**Planning Department  
Transportation Development Services**

**Re: Wendy's, 3601 4<sup>th</sup> St NW**  
**Traffic Circulation Layout**  
Architect's Stamp dated 6-26-14 (G14-D031)

PROJECT  
 WENDY'S 4TH STREET STORE (STORE #3104)  
 ADDITION AND PROTOTYPE REMODEL

EXISTING/DEMO SITE PLAN  
 REMODEL AND TCL SITE PLAN

REMODEL/ADDITION SITE PLAN  
 10 5 0 20  
 1" = 20'-0"

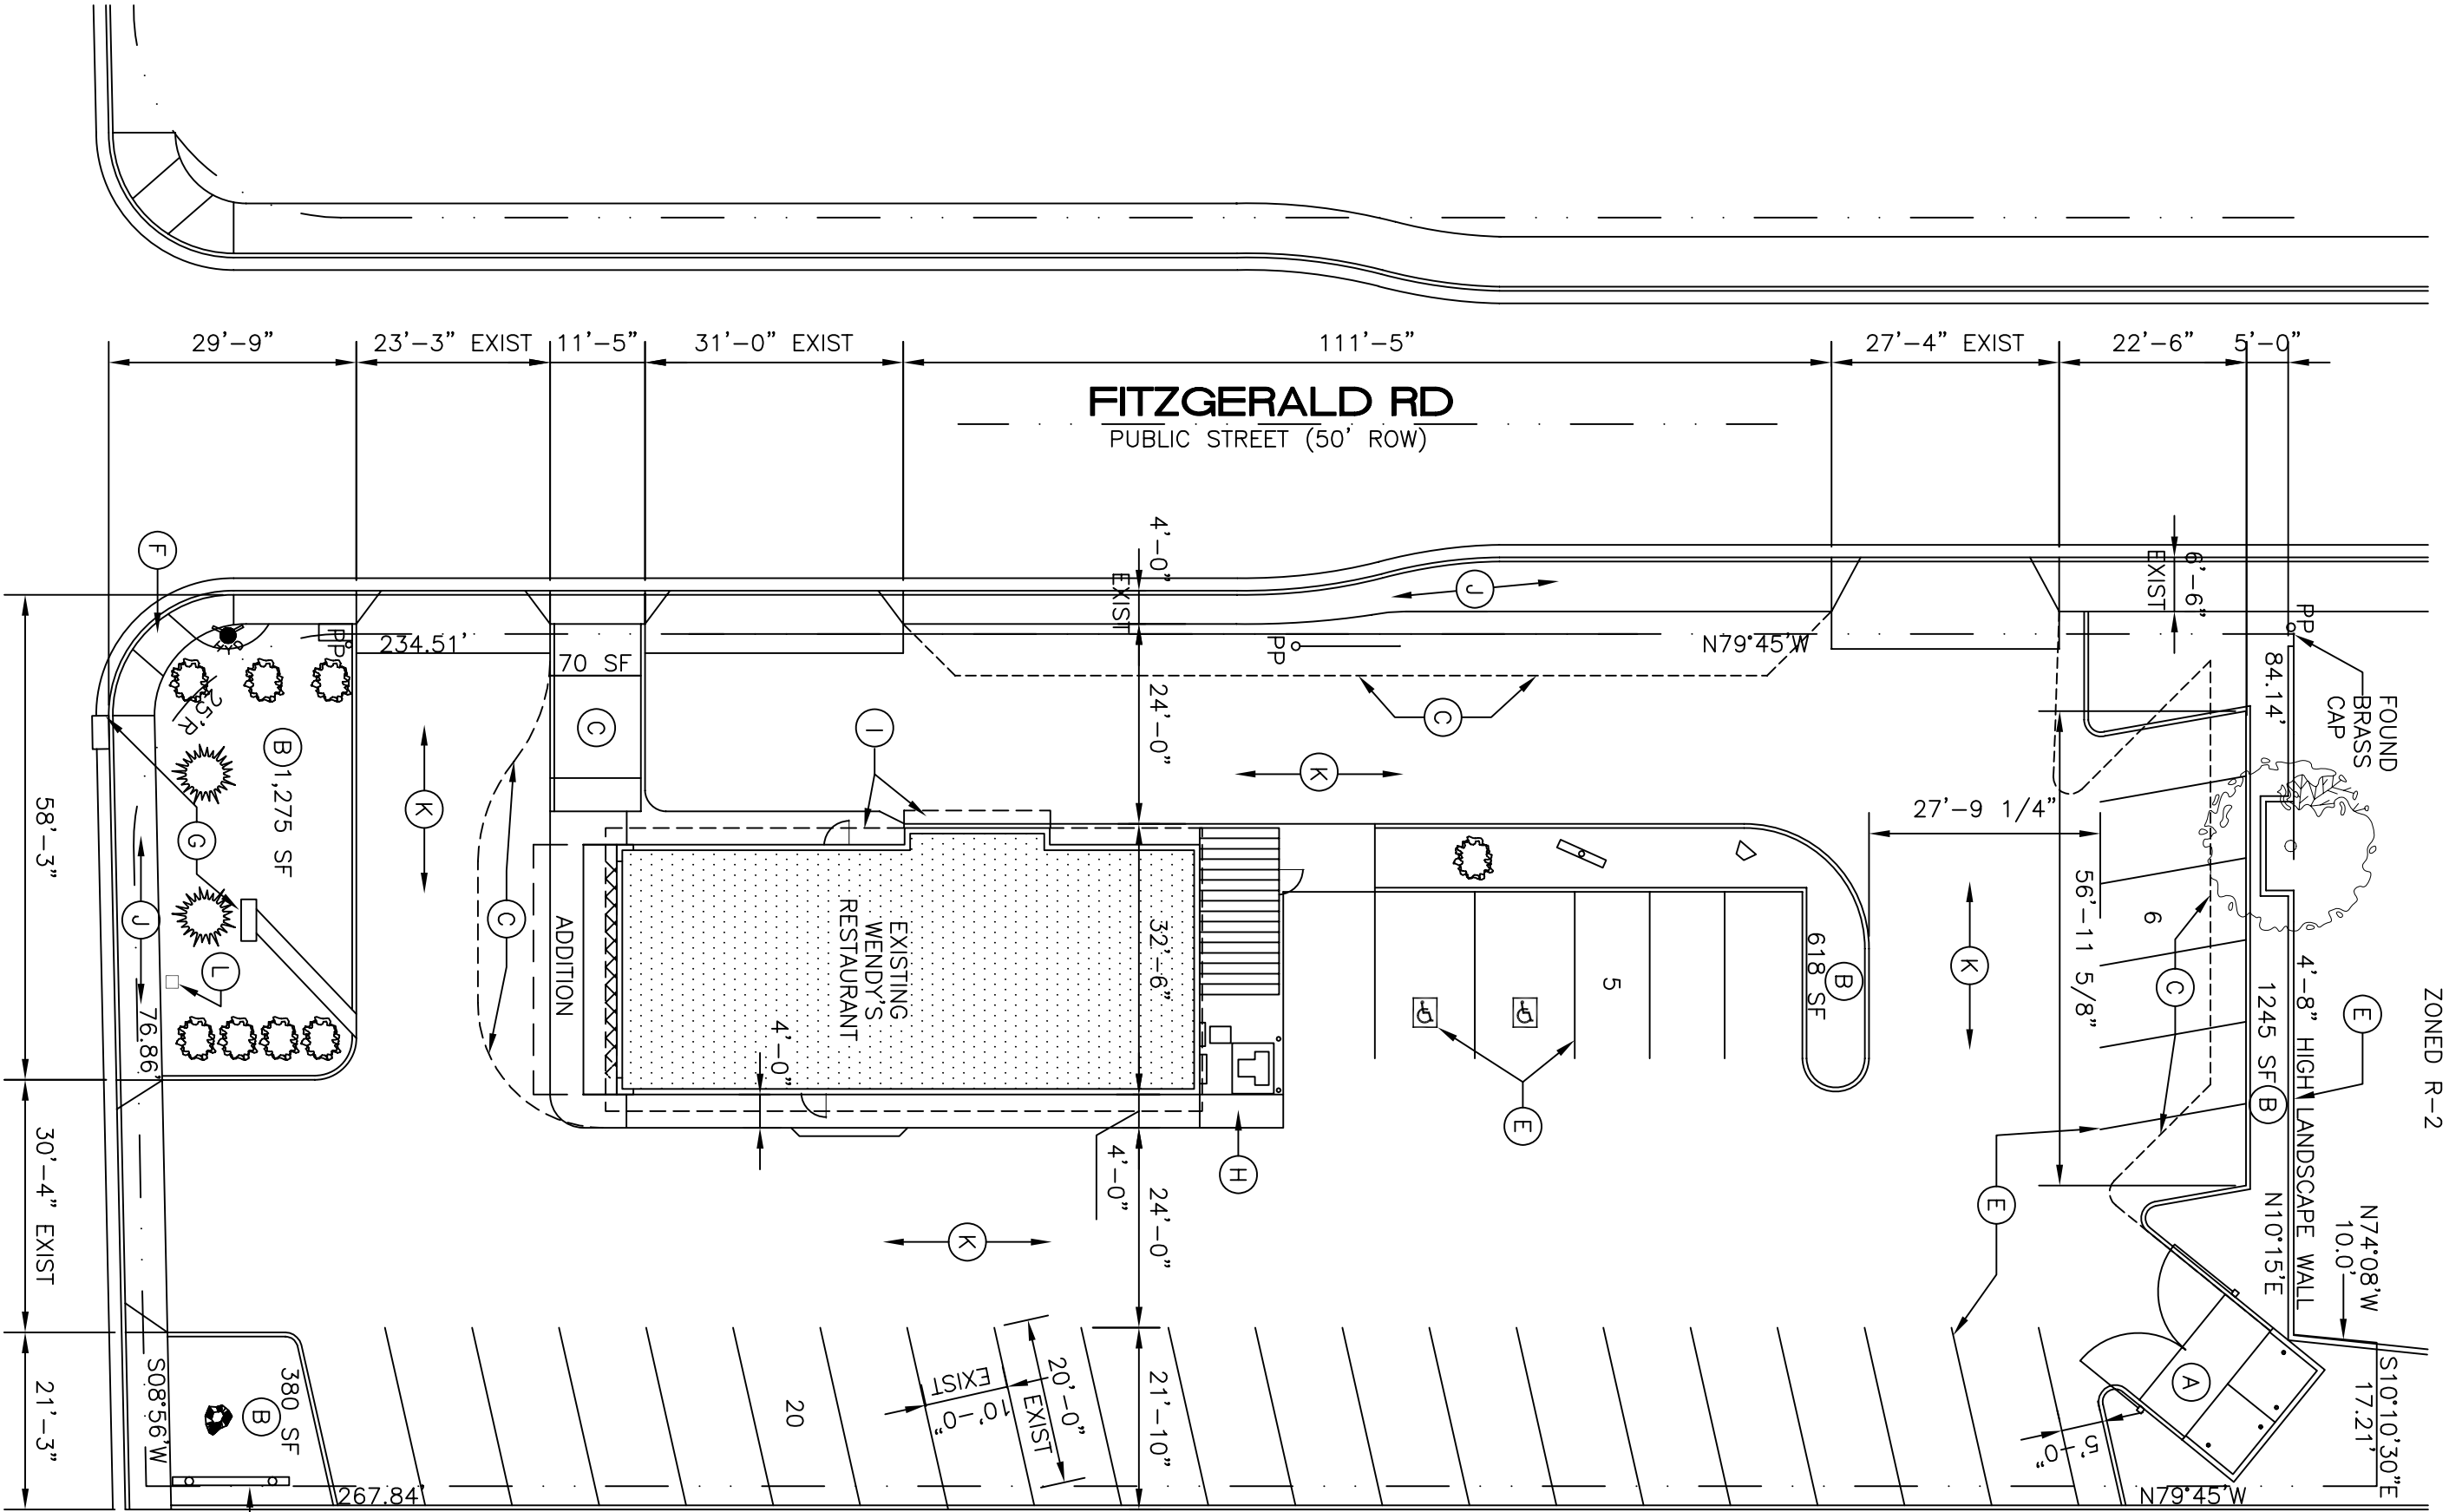
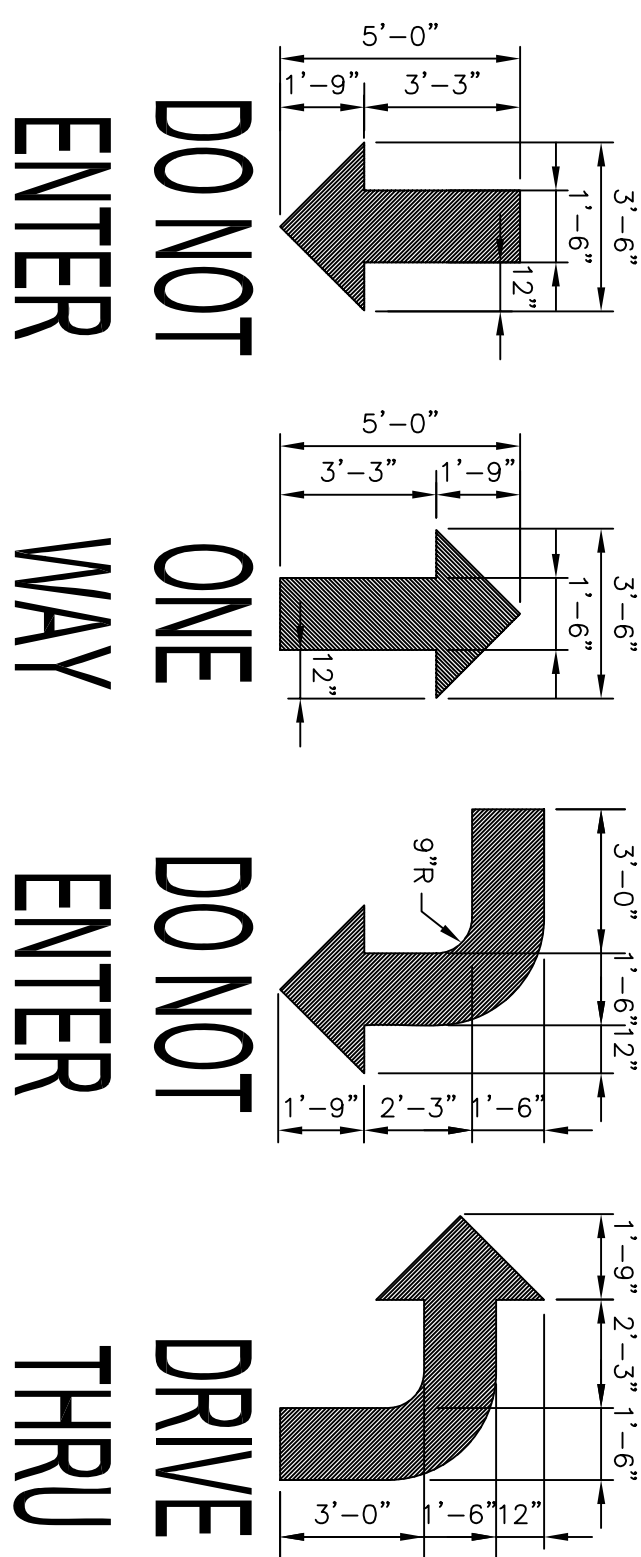
1. Please list the width and length for all parking spaces.
2. Please show a vicinity map.
3. The handicap accessible spaces must be a minimum of 8.5 feet in width.

4. The handicap accessible spaces must include an 8-foot wide van access aisle; all other aisles should be 5 feet in width.
5. Please provide a detail of the handicap accessible parking signage

6. Provide a heavy vehicle pathway on the plan.
7. Please include two copies of the traffic circulation layout at the next submittal.
8. Show the pedestrian pathway and ADA access to the building including all ramps.

9. How will ADA access be taken to the entrance of the building? The door appears to swing in the path way.
10. Please provide an easement for any sidewalk within the right-of-way.

11. Please provide approvable signage and striping i.e. one-way and do not enter.
12. Please remove non applicable note "7" from the TCL plan.
13. We suggest that the parking on the west end of the property be changed to compact parking to widen the drive aisle.
